## **SECTION 4.55(1A) MODIFICATION APPLICATION - SSD 8903 Stage 1 of Ivanhoe Estate (Midtown), Macquarie Park**

This application has been prepared by Ethos Urban on behalf of Frasers Property Australia, pursuant to section 4.55(1A) of the *Environmental Planning and Assessment Act 1979* (EP&A Act) to modify SSD-8903 relating to Ivanhoe Estate (the site).

This modification seeks a minor increase in the approved height of Building A1 by a total of 565mm, resulting in a maximum building height of 75.365m. This change to height is due to construction detailing issues requiring additional structure and insulation which was not considered in the original approval due to revisions to the National Construction Code (NCC) post approval.

**Figure 1** Approved height (east elevation)

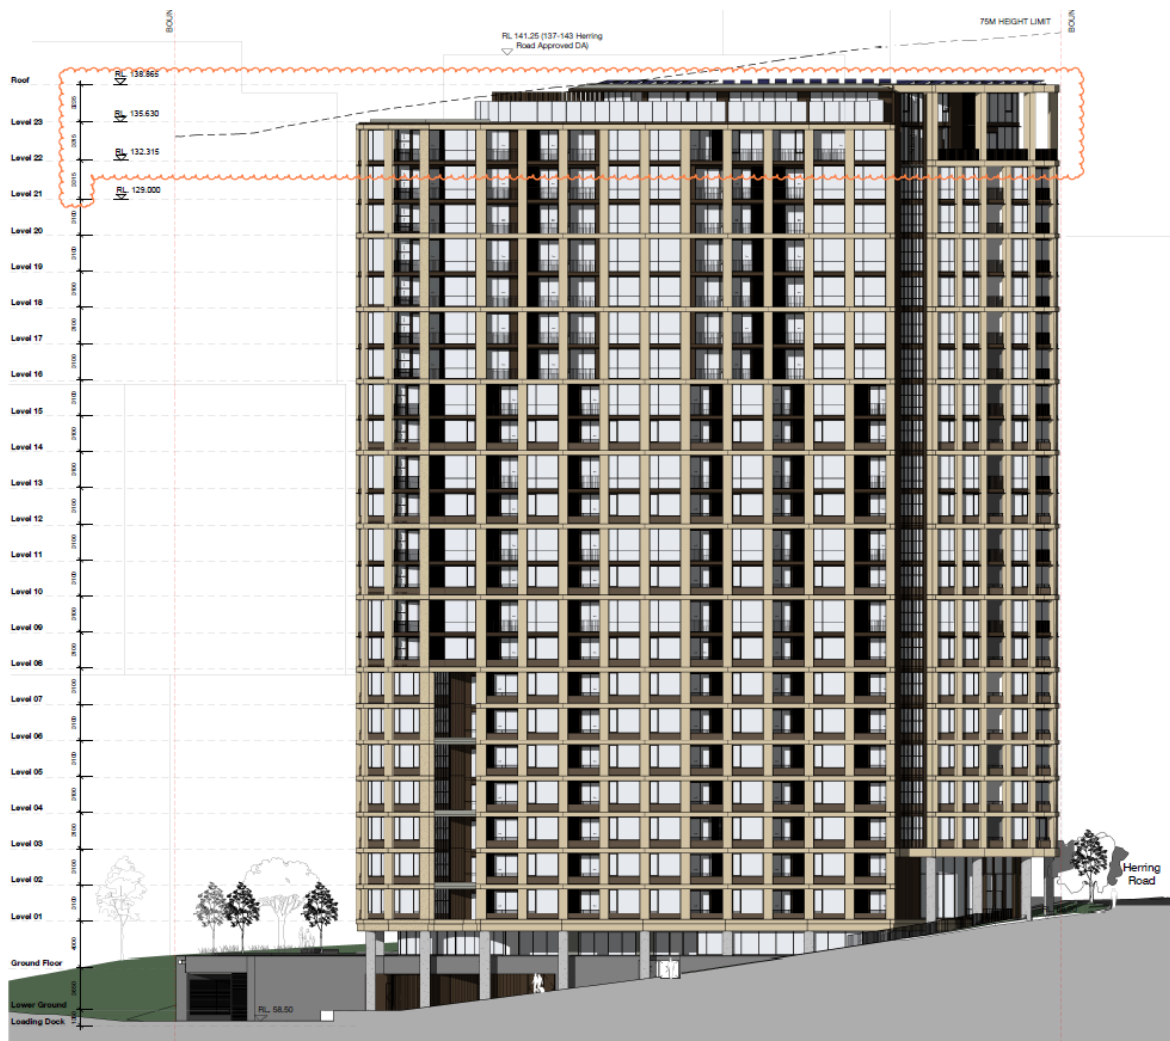
Stage 1 of the Ivanhoe Estate redevelopment approved a maximum building height of 74.8m. This proposed modification involves a minor amendment to the height of Building A1, increasing the height by 565mm from a maximum of 74.8m to 75.365m as illustrated at **Figure 1-4**. The increase in height is driven by construction detailing issues arising from revisions to the NCC. Subsequently, an increase of 565mm to the building height is required to comply with the NCC, specifically pertaining to the stepped massing of the building with external areas above internal areas requiring additional structure and insulation which was not accounted for in the original approval.

**Figure 5** Approved (winter solstice 12pm)

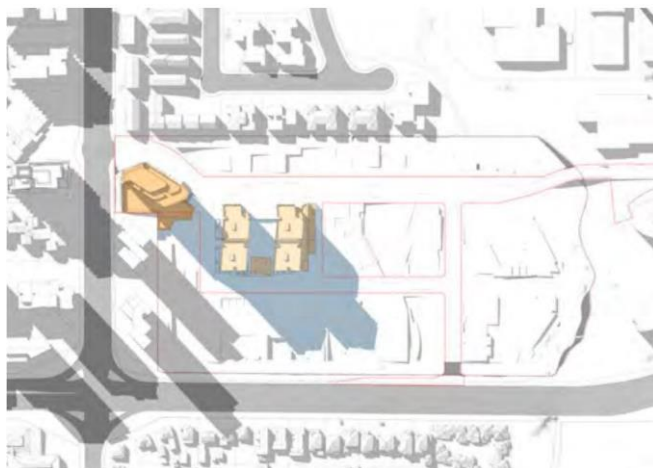
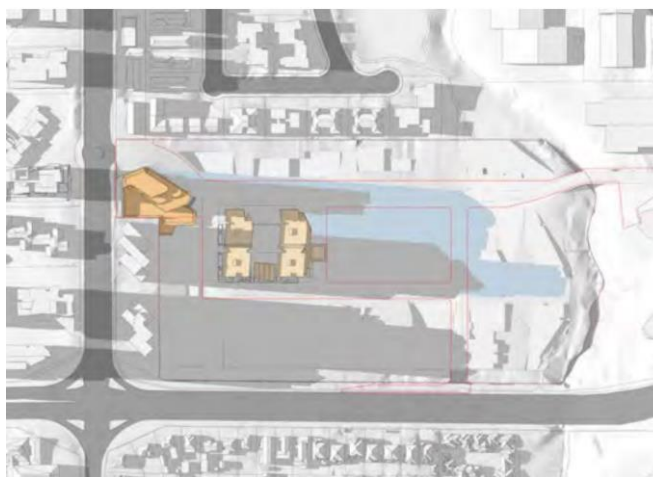
Further, the increase in building height does not impact upon the amenity of the development, remaining consistent with the approved Stage 1. There is also a negligible overshadowing impact resulting from the proposed modification as illustrated at **Figures 5–8**. The minor additional overshadowing resulting from the development also does not result in any additional overshadowing on adjoining properties outside of the Ivanhoe Estate site.
